CITY OF MOBILE
TIGER 2016 Project Phase Four- Dr. Martin Luther King Jr. Ave from NW of Butchers
Lane to Beauregard St
Project No. 2023-2045-01

ADDENDUM #2

This addendum includes the following: (1) revised contract language, (2) revised PROPOSAL form (Attachment "A"), (3) responses to remaining questions and (4) updated plan sheets (Attachment "C"). This addendum consists of a total of 93 pages, including the cover page.

SUMMARY OF PLAN SHEET CHANGES

REFERENCE PROJECT NO	FISCAL YEAR	SHEET NO
2023-2045-01 TIGER-FAUP- 4917(250)	2025	408

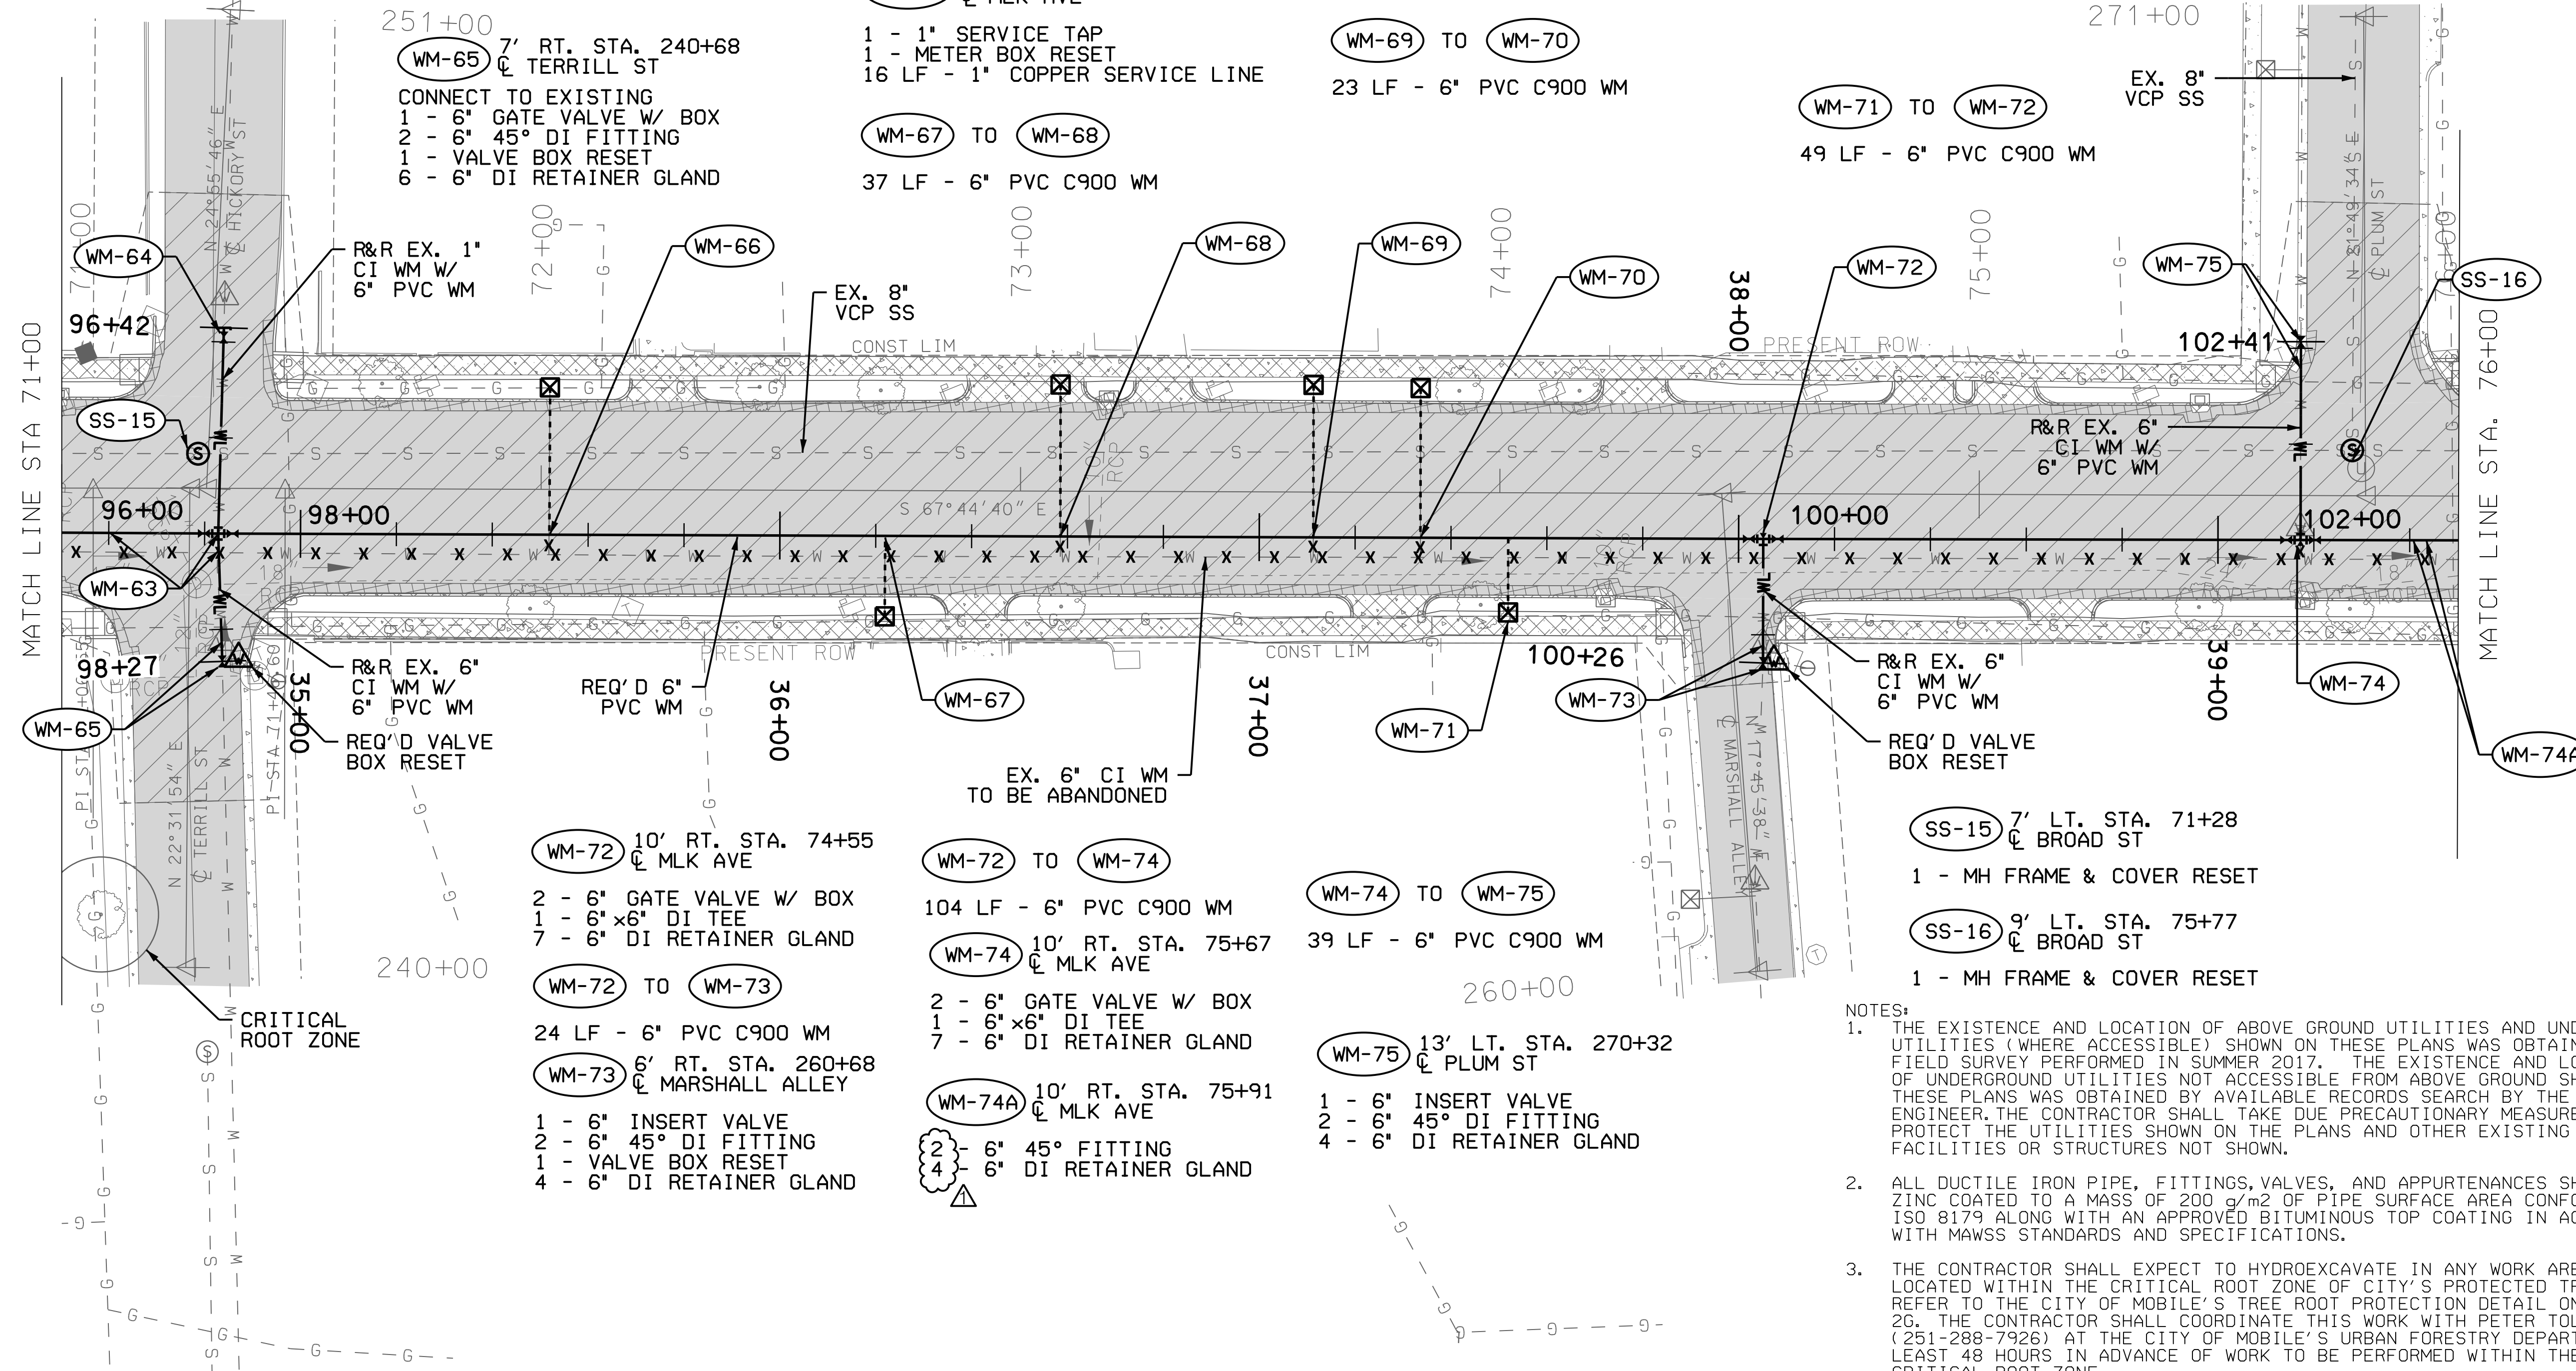
- Callout WM-54 – Revised retainer gland quantity
- **SHEET 408**
 - Callout WM-53 to WM-55 – Revised pipe length quantity
 - Callout WM-55 to WM-56 – Revised pipe length quantity

REFERENCE PROJECT NO	FISCAL YEAR	SHEET NO
2023-2045-01 TIGER-FAUP-4917(250)	2025	410

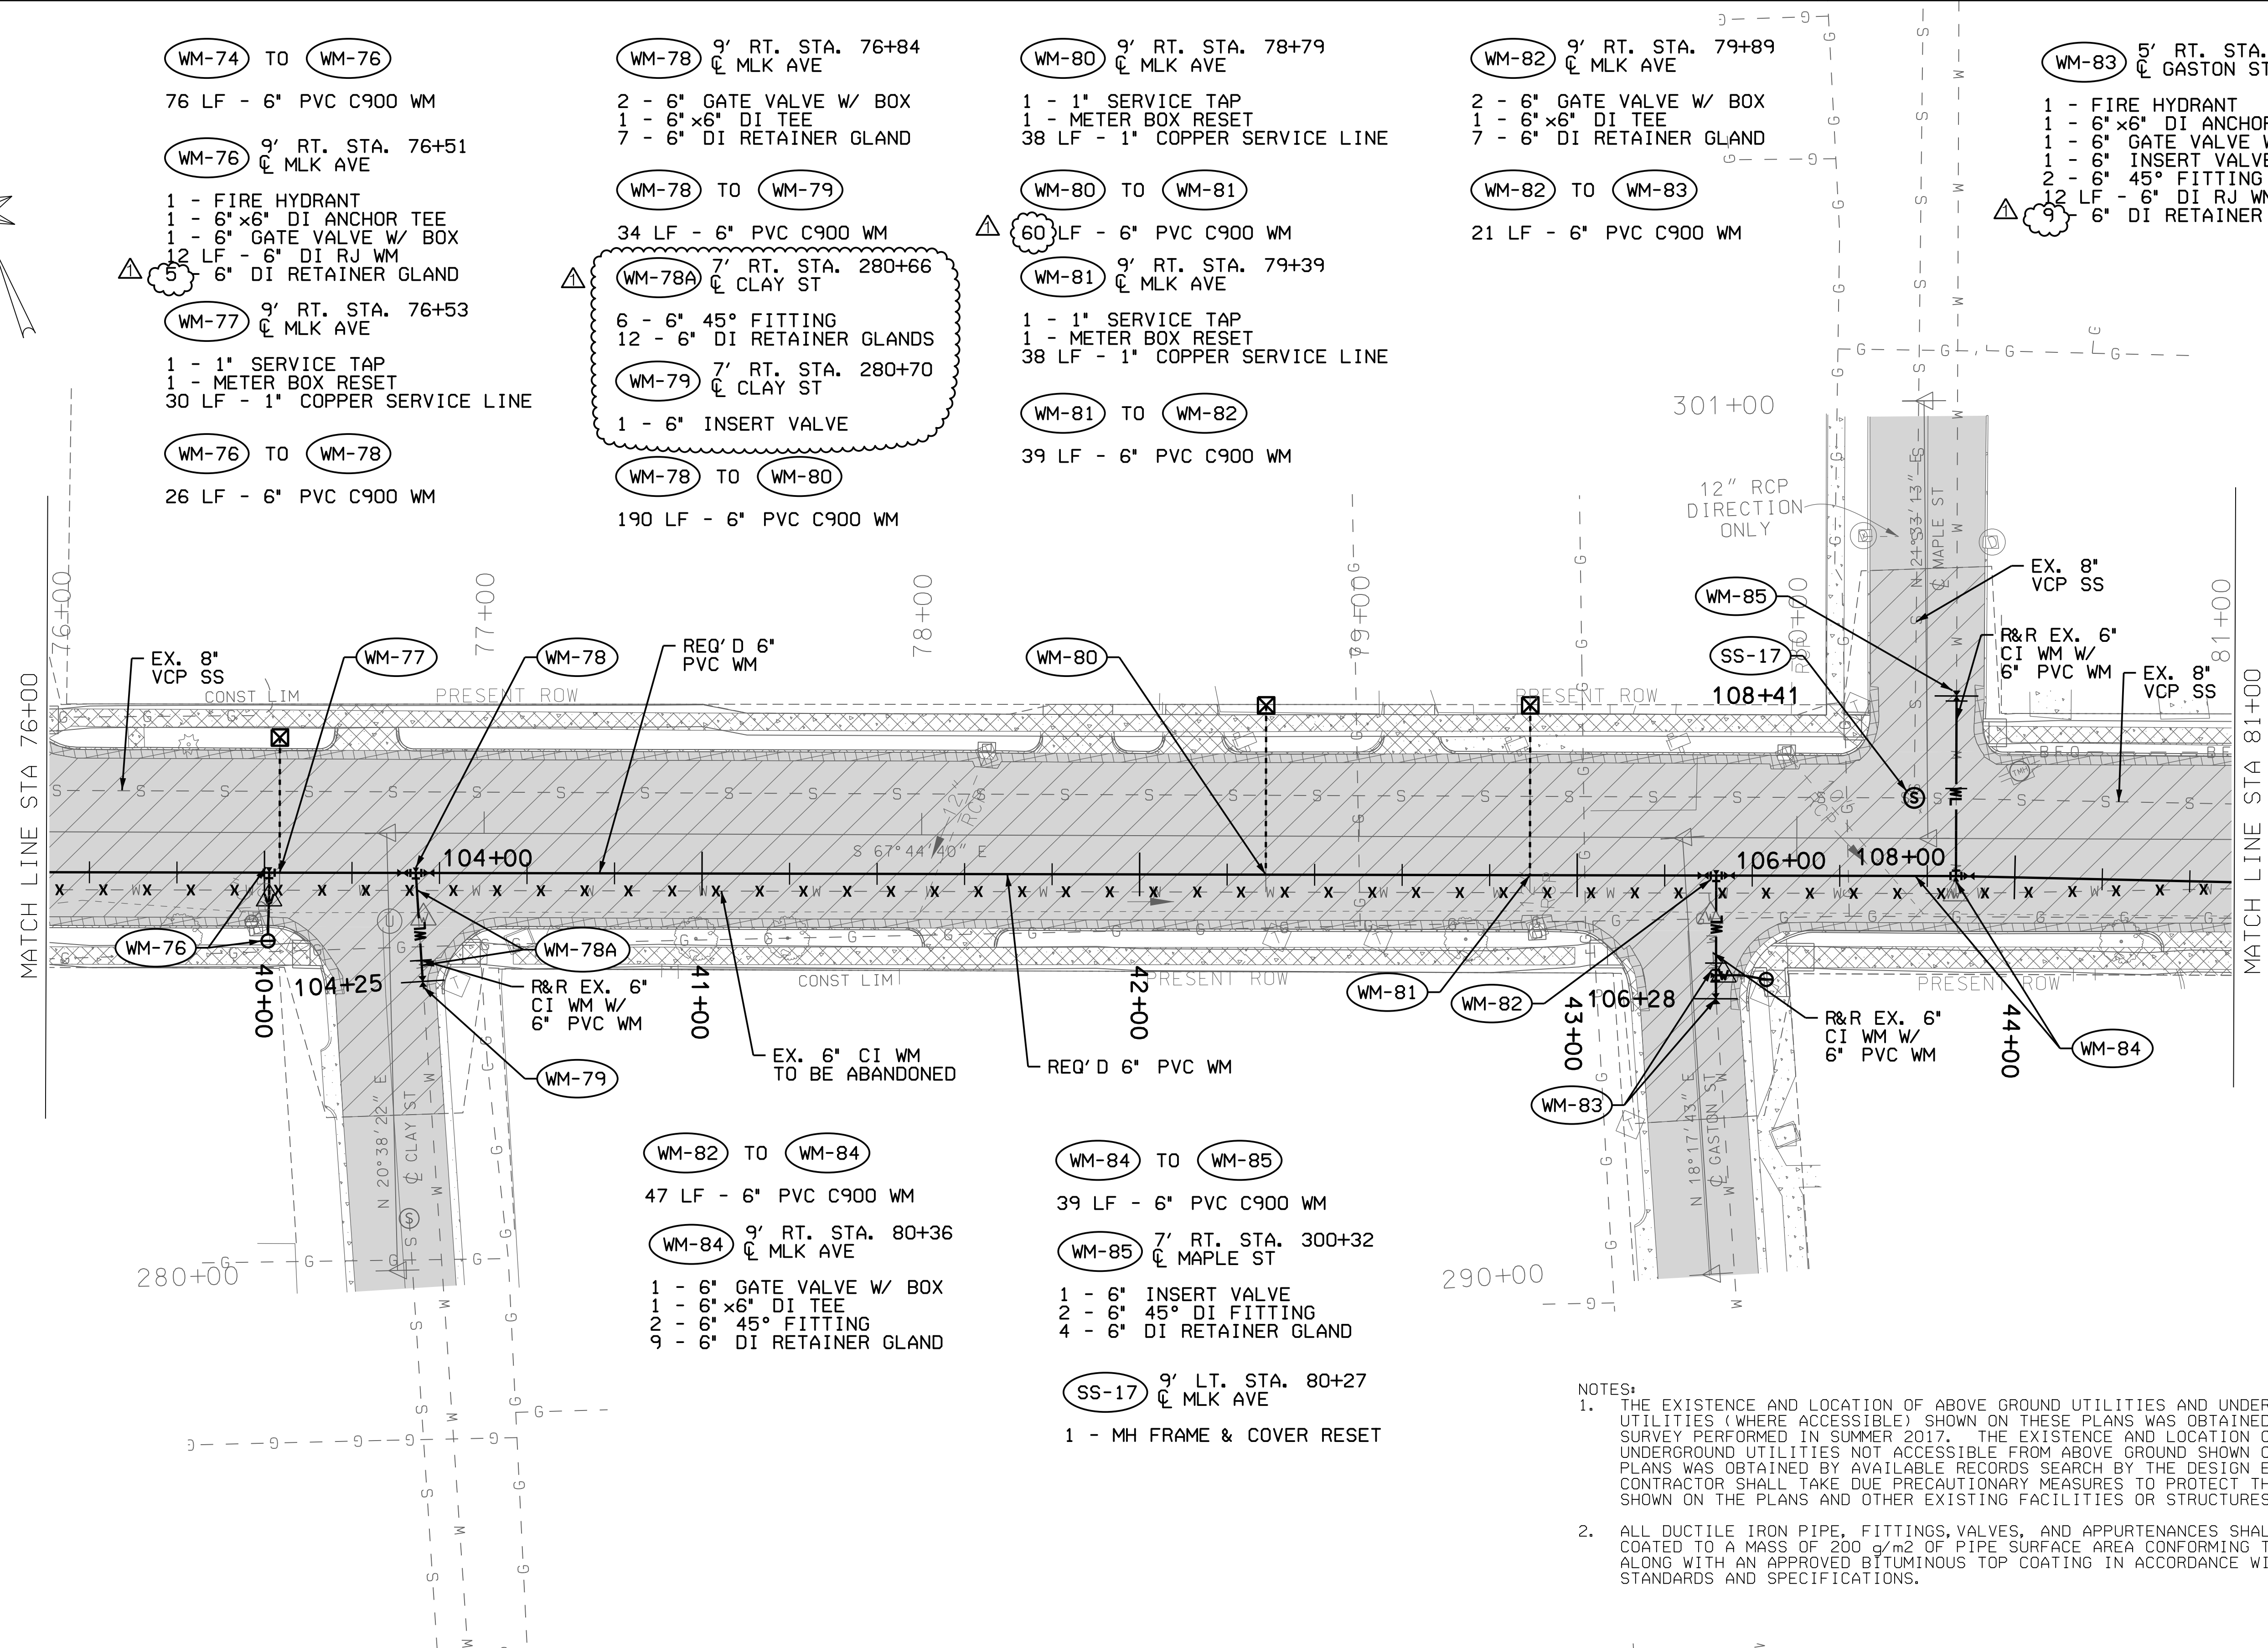
- **SHEET 410**
 - Callout WM-76 – Revised retainer gland quantity
 - Renumbered WM-79 to read WM-78A
 - Renumbered WM-78A to read WM-79
 - Callout WM-80 to WM-81 – Revised pipe length quantity

- Callout WM-83 – Revised retainer gland quantity
- **SHEET 411**
 - Callout WM-86 – Removed 45° fittings and retainer glands quantities
 - Callout WM-92 – Revised retainer gland quantity

REFERENCE PROJECT NO	FISCAL YEAR	SHEET NO
2023-2045-01 TIGER-FAUP-4917(250)	2025	411A

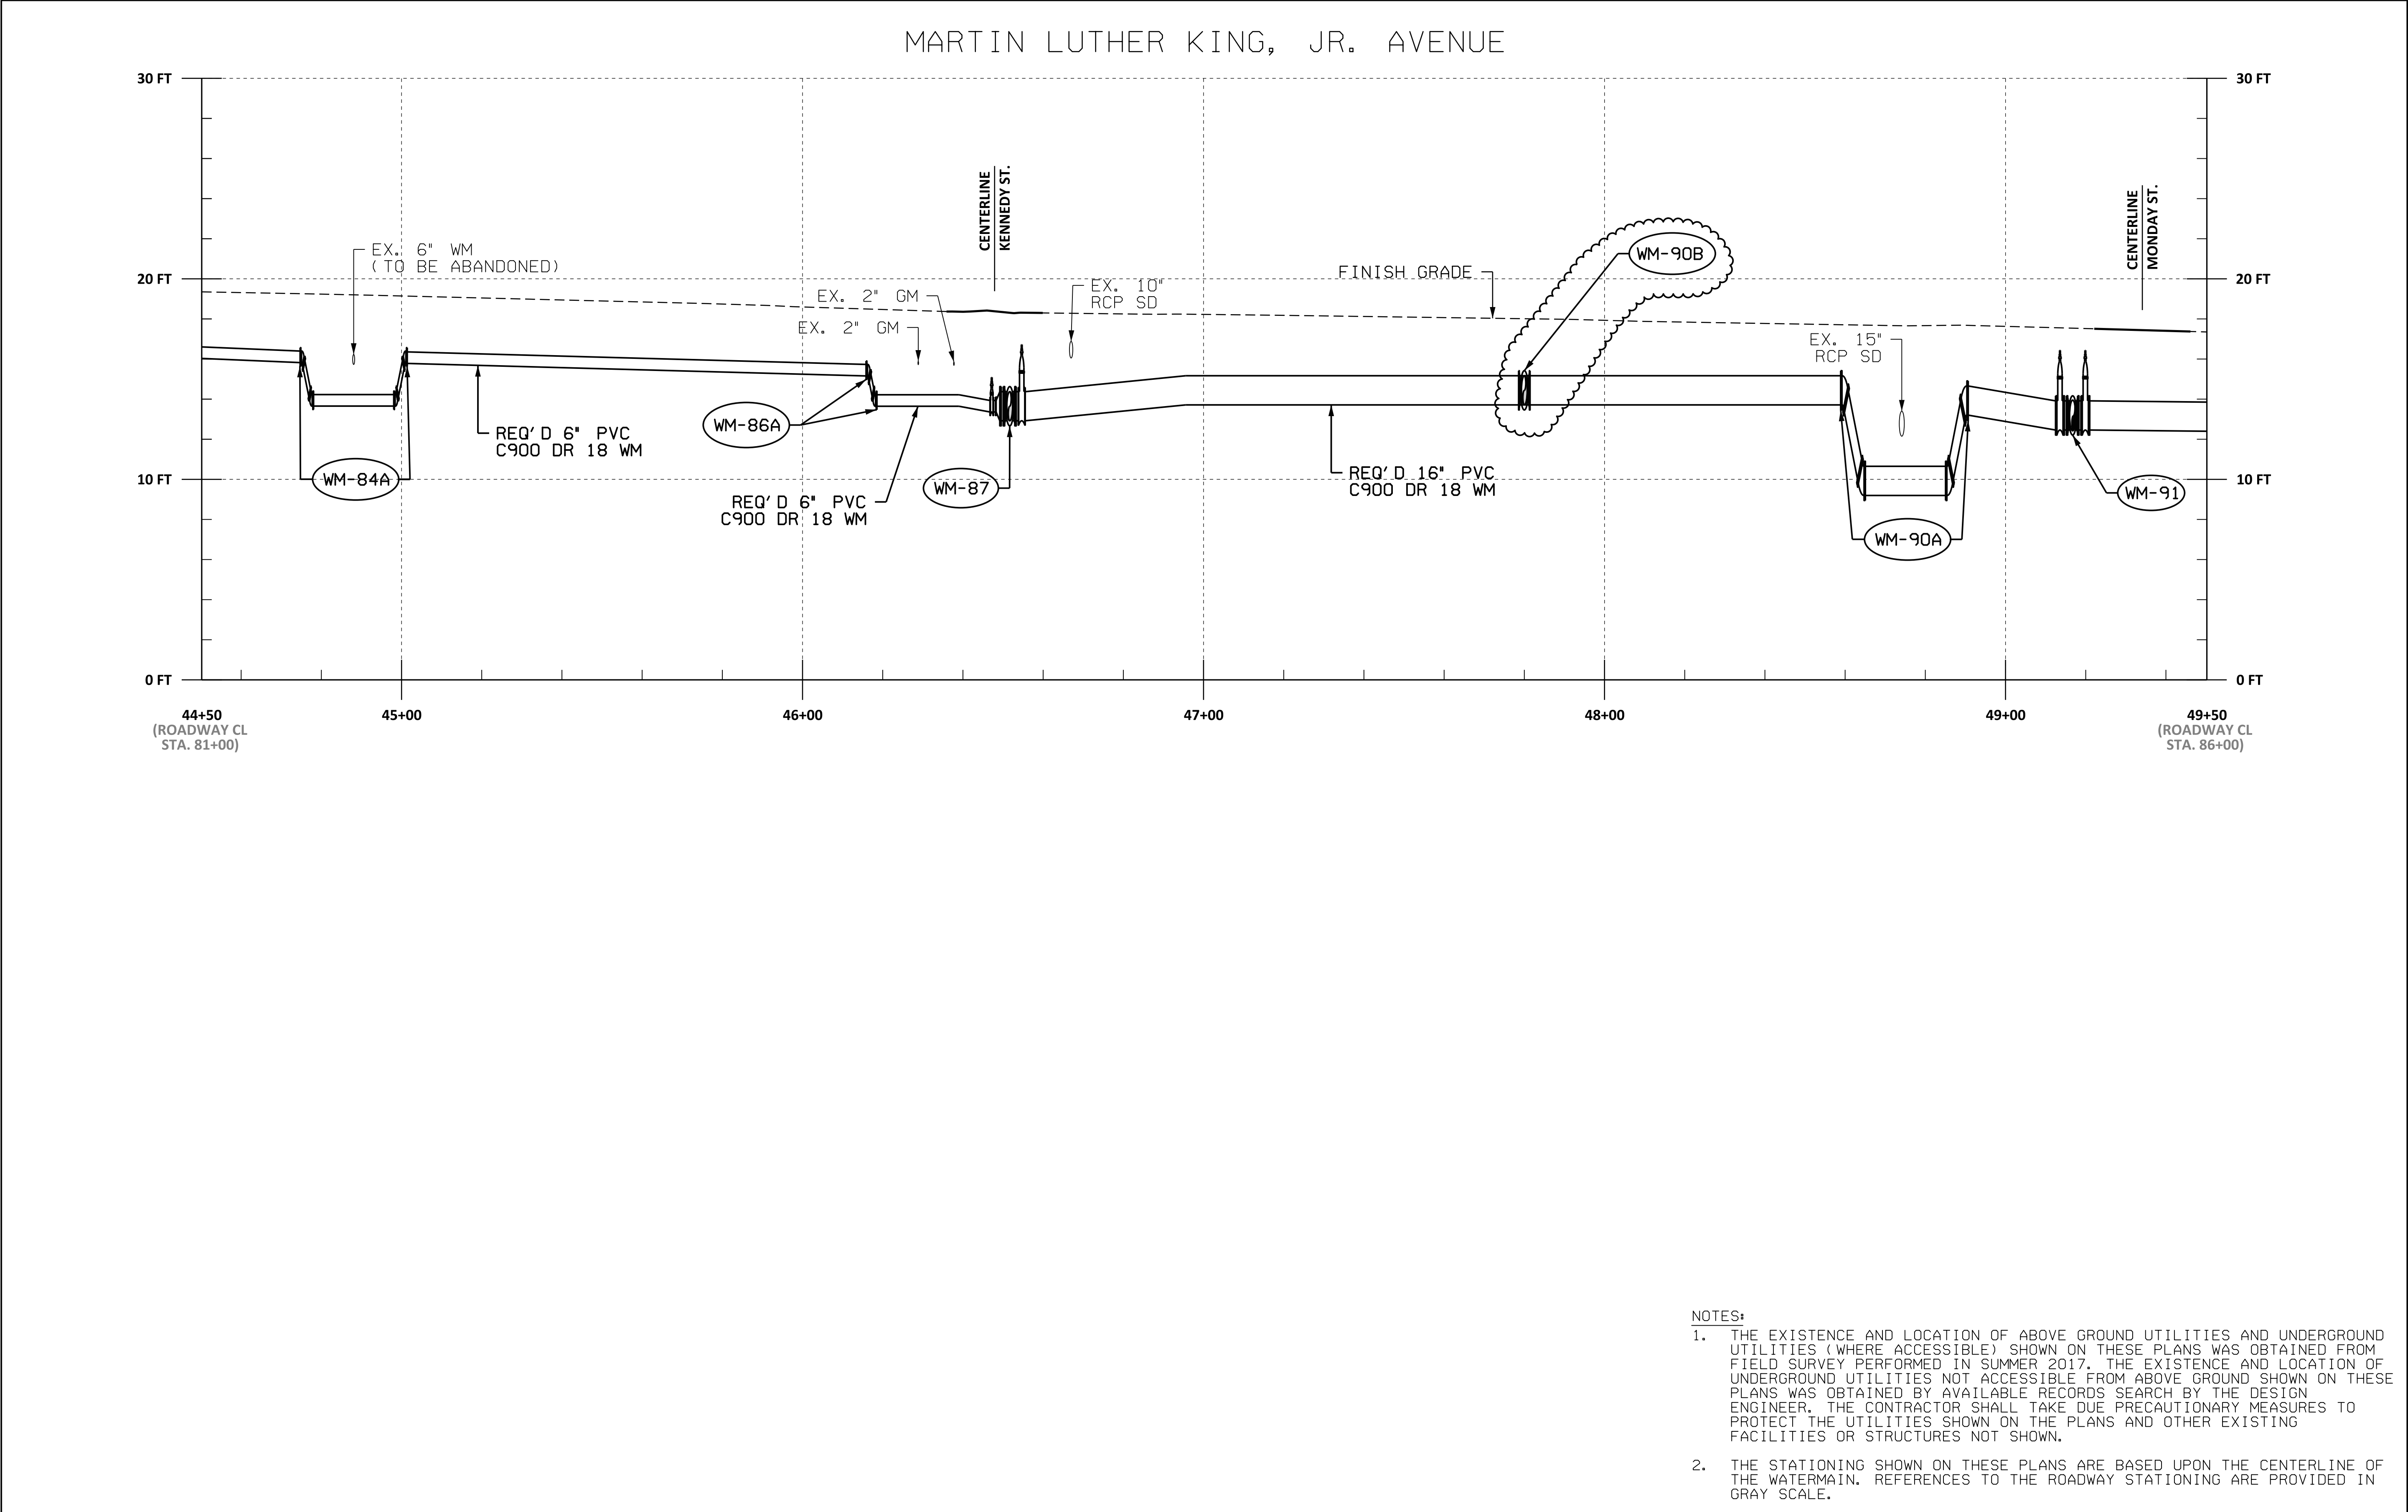
- 3 – 6” DI Retainer Glands
- **SHEET 411A**
 - Added symbology and Callout **WM-90B** to profile
- **SHEET 412**
 - Callout WM-93 and WM-96 – Modified leader arrows
